THE FAIRGROUNDS

Site Plan / Subdivision / Special Use Application

FINAL ENVIRONMENTAL IMPACT STATEMENT

NYS Route 94 (New Milford Road)
TOWN OF WARWICK, ORANGE COUNTY, NEW YORK
Tax Map Number:
Section 51, Block 1, Lot 40

Figure 8-1: Sight Lines to Water Tower
 Fairgrounds Site
 Town of Warwick, Orange County, NY
 Source: Lehman & Getz, P.C., 04/2005
 Scale: As Shown

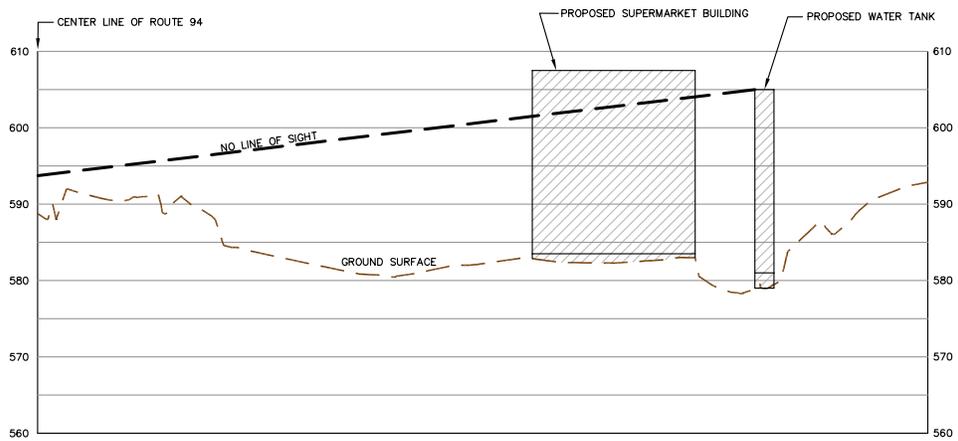
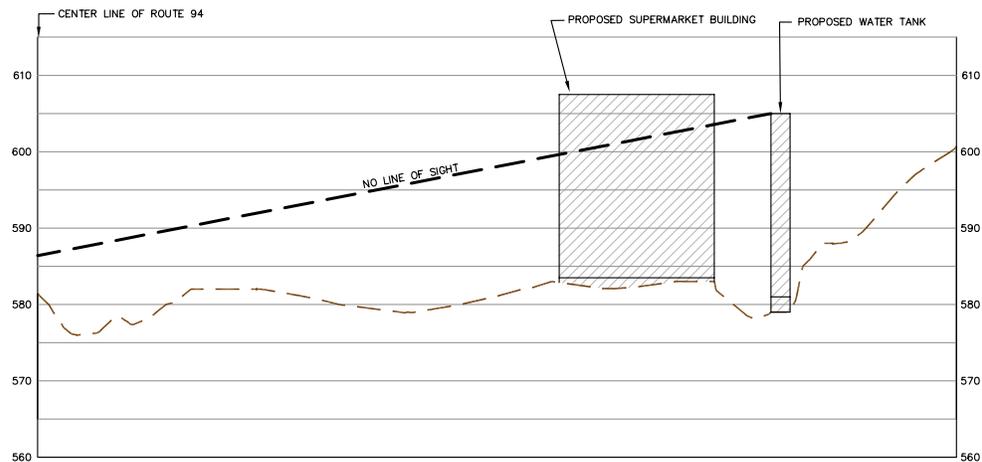
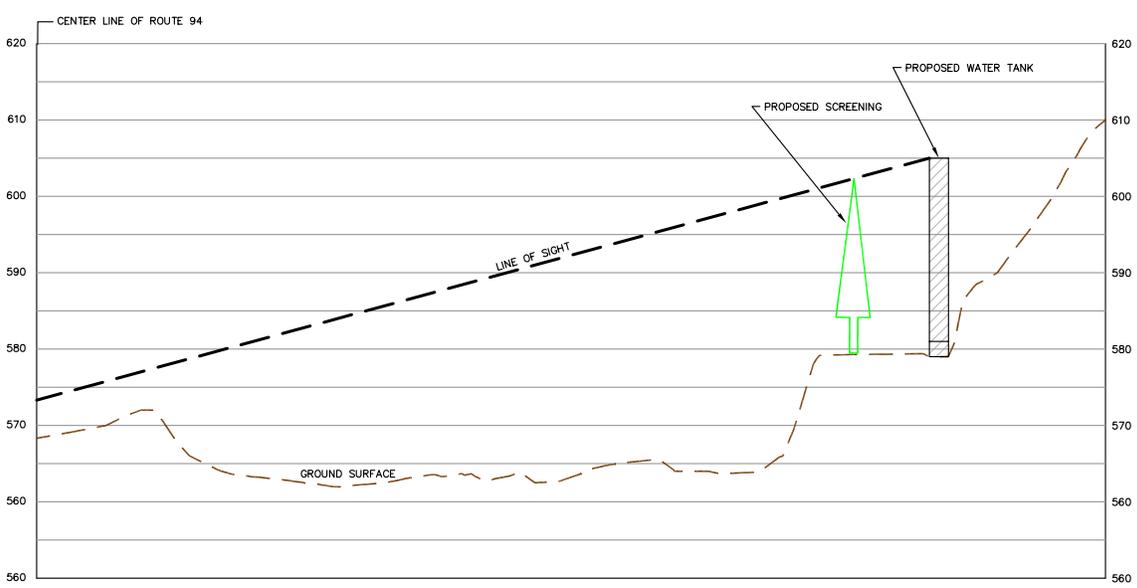
Pages 2-6 and 2-10 contain an identical one-sentence reference to the proposed 60,000-gallon water tank. The DEIS contains no discussion of the size, height and paint color of the water tank, nor does it discuss any required lighting or potential use for mobile telephone or similar transmission facilities. The Executive Summary Section 1.2.10 on page 1-23 asserts the proposed water tank “will be hidden from view from off-site viewpoints” but there is no further explanation of how this is accomplished. The illustrative aerial view at Figure 2-6 and the Post-Development Views from Route 94 at Figures 3.10-10 and 3.10-11 omit the water tank.

Response 8-5: *Cross sections showing the size, height and location of the water tank are included at the end of this section (Figure 8-1). The water tank is proposed to be approximately 24 feet in height and 25 feet in diameter. The tank will be painted a neutral green and given its location at the rear of the project site and behind the supermarket building, it will be unobtrusive in any view of the site from Route 94. As shown in the cross sections, the supermarket will hide view of the tank from all view points on Route 94 except the extreme southeast corner of the site. To augment the line of street trees proposed along the eastern side of the supermarket parking lot, a row of evergreen trees will be added to the landscape plan on this potential sight line as indicated in Figure 8-2.*
